Renovation and Conversion of Robert Bateman High School

EICS-12-23

To Council

Sept 26, 2023

Extent of Phase 2 Parking, Tender Documents

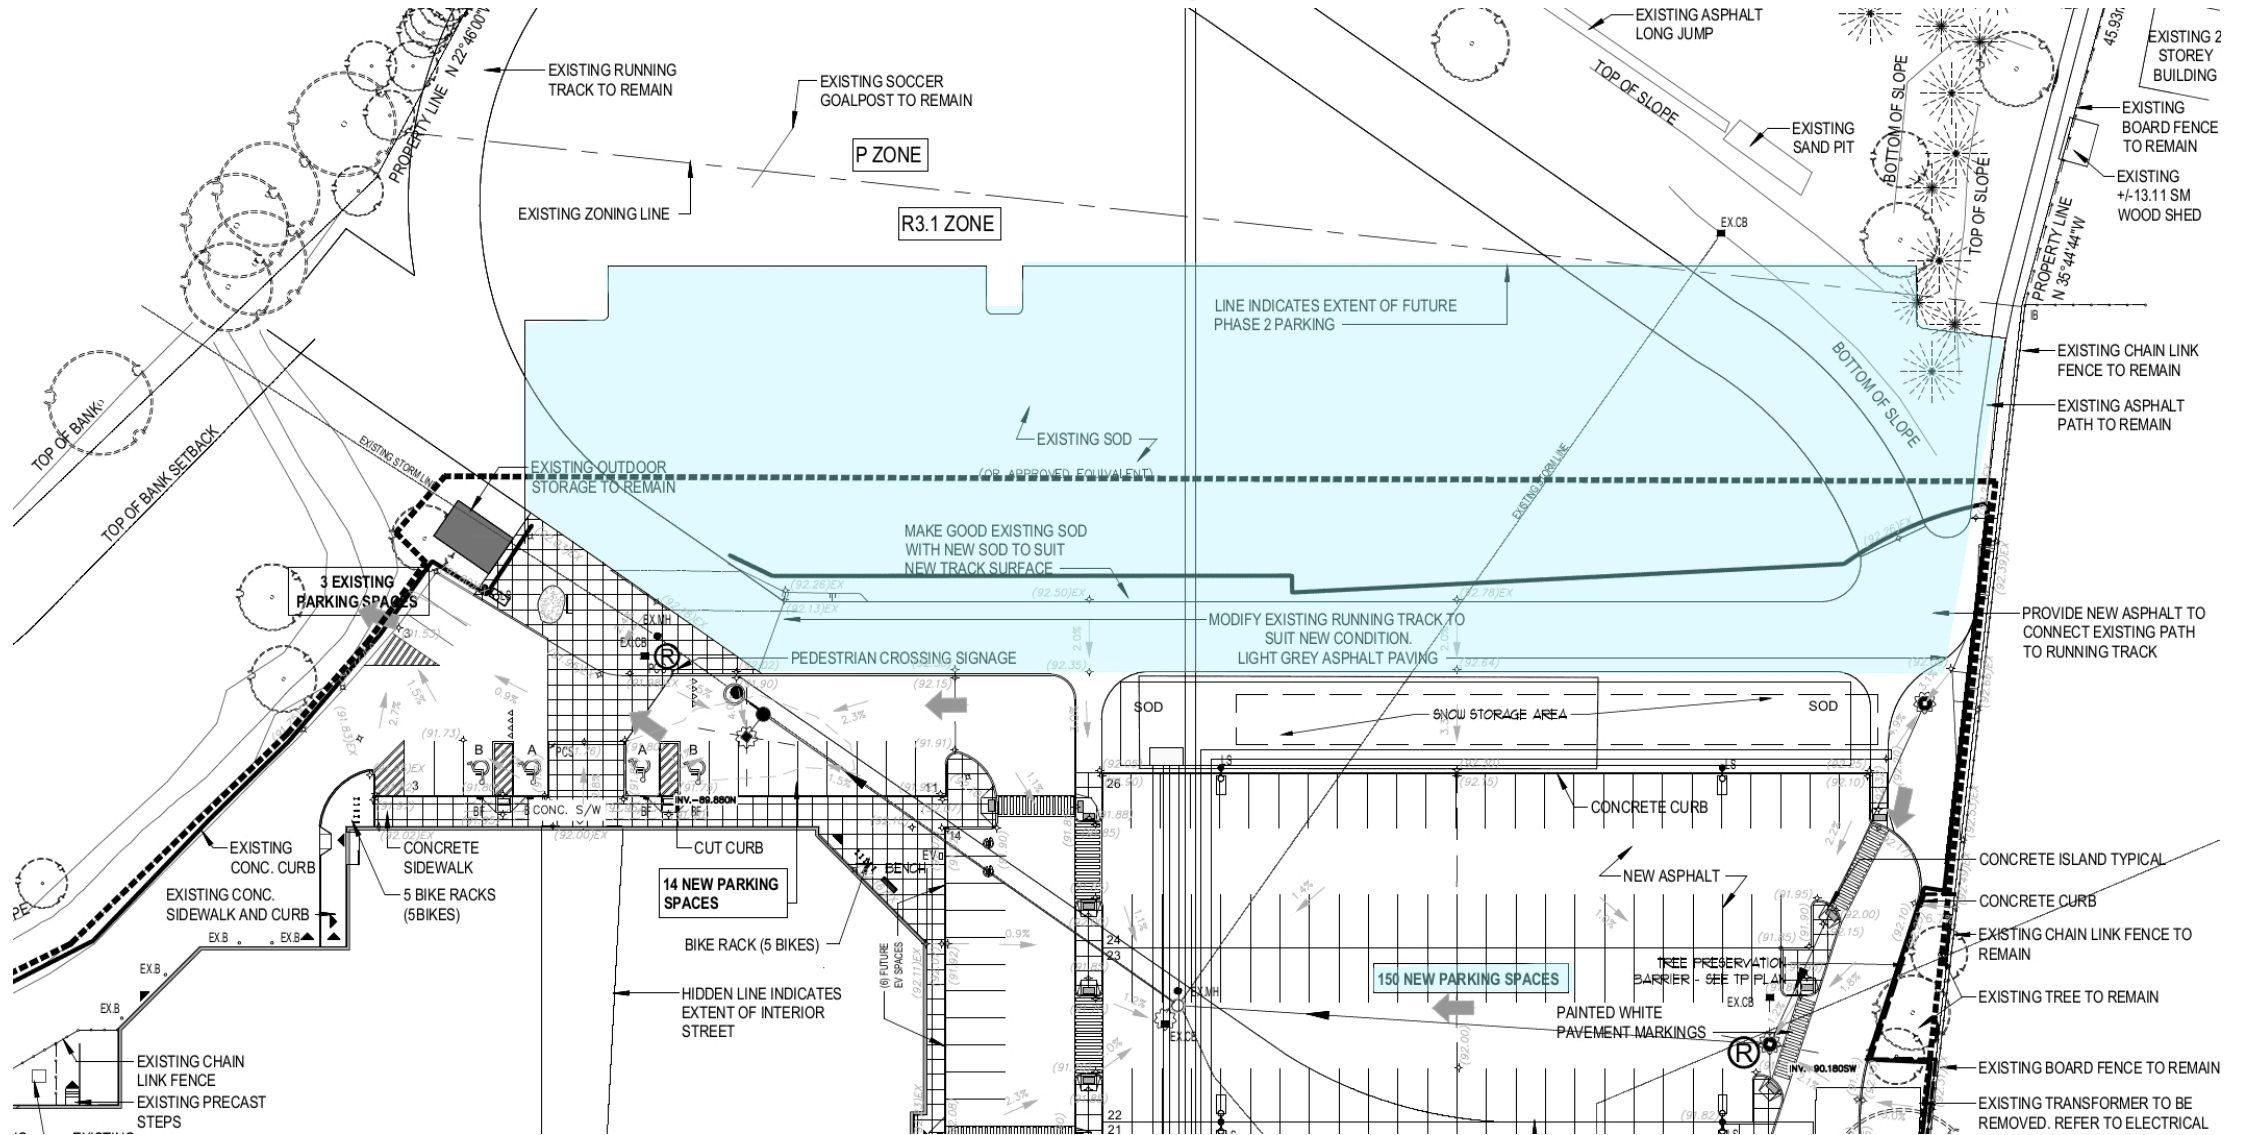
Existing Site Plan – Phase 1

Existing Parking Spots: 235

New spots: 74

Total Phase 1: 309

SITE PLAN - PHASE 1

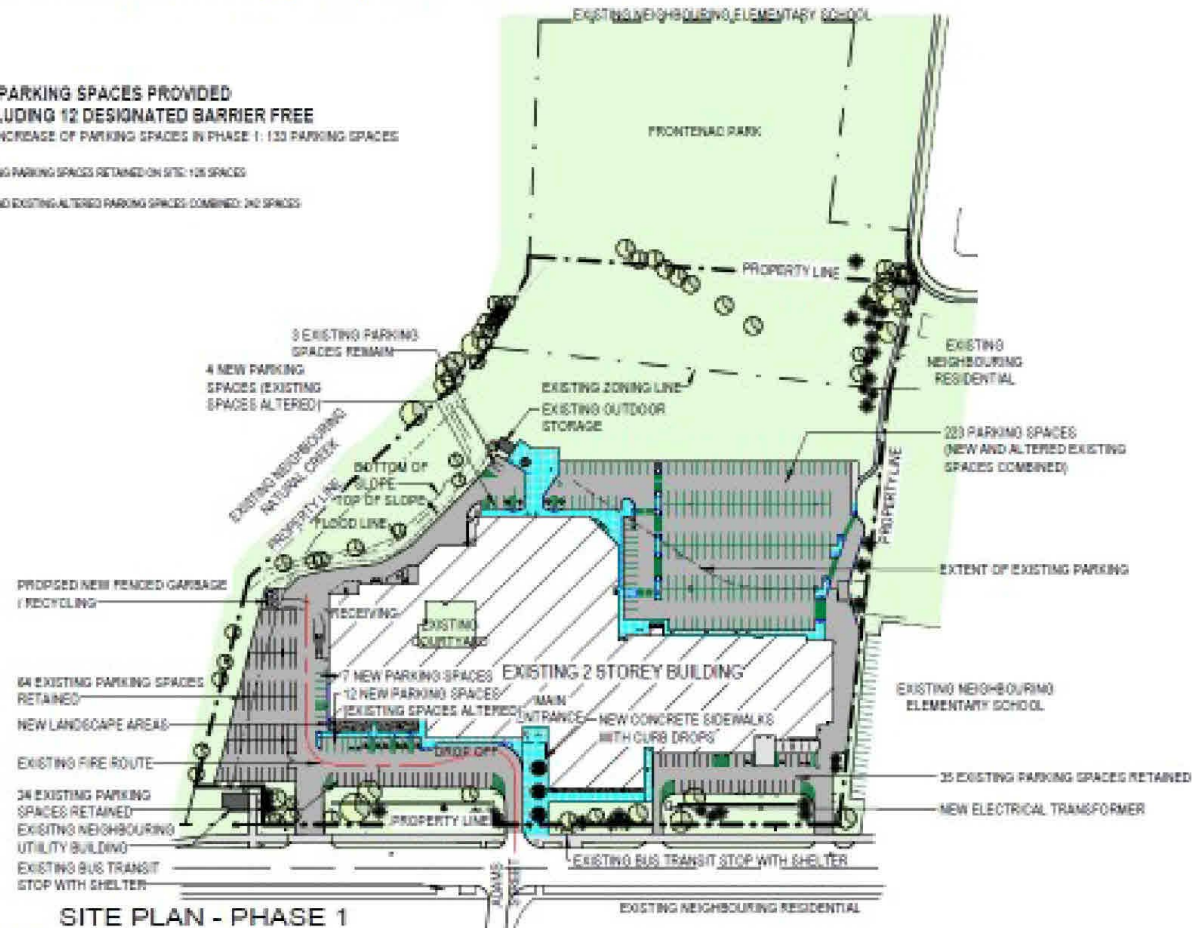
Phase I – 368 Parking Spaces

368 PARKING SPACES PROVIDED
INCLUDING 12 DESIGNATED BARRIER FREE
NET INCREASE OF PARKING SPACES IN PHASE I: 133 PARKING SPACES
EXISTING PARKING SPACES RETAINED ON SITE: 108 SPACES
NEW AND EXISTING ALTERED PARKING SPACES COMBINED: 240 SPACES

SITE PLAN - PHASE 2

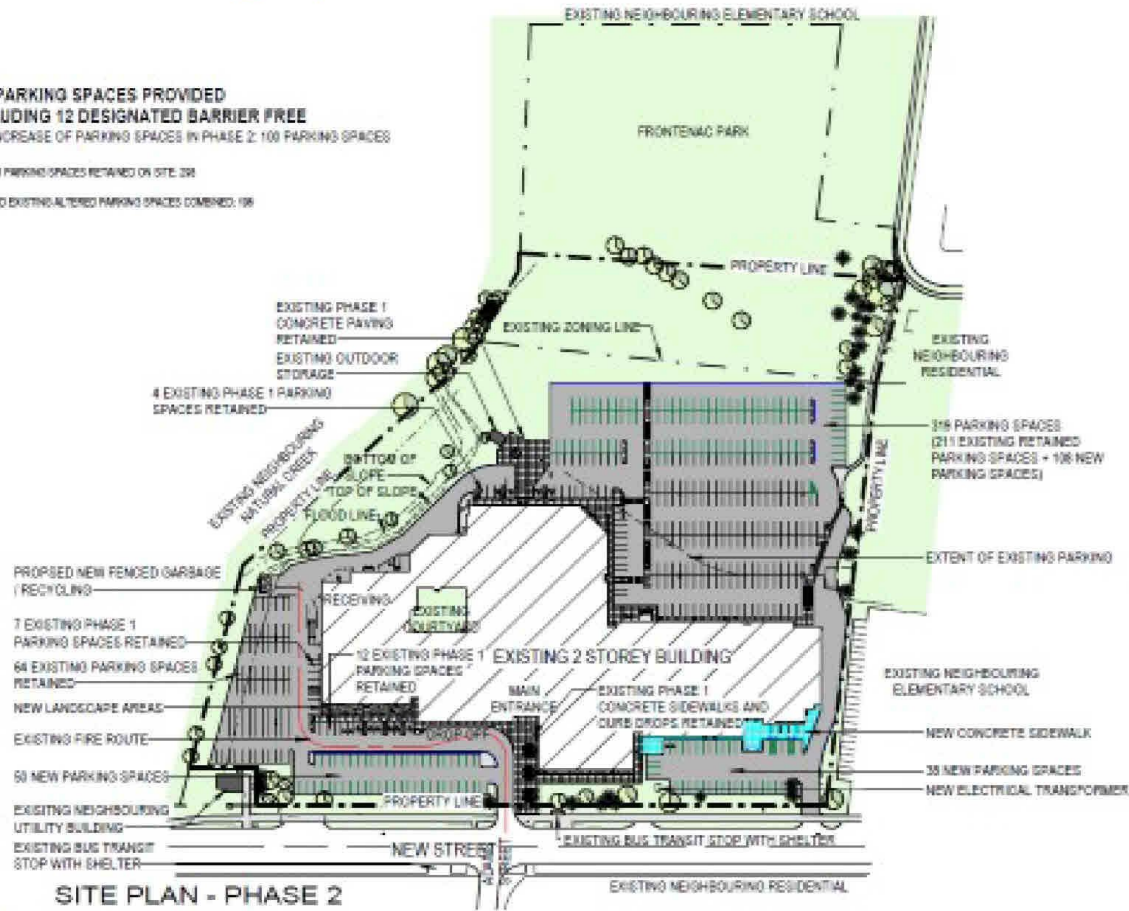
Phase II – 468 Parking Spaces

468 PARKING SPACES PROVIDED
INCLUDING 12 DESIGNATED BARRIER FREE
NET INCREASE OF PARKING SPACES IN PHASE 2: 100 PARKING SPACES

PHASE 1 PARKING SPACES RETAINED ON SITE: 326

NEW AND EXISTING ALTERED PARKING SPACES COMBINED: 138
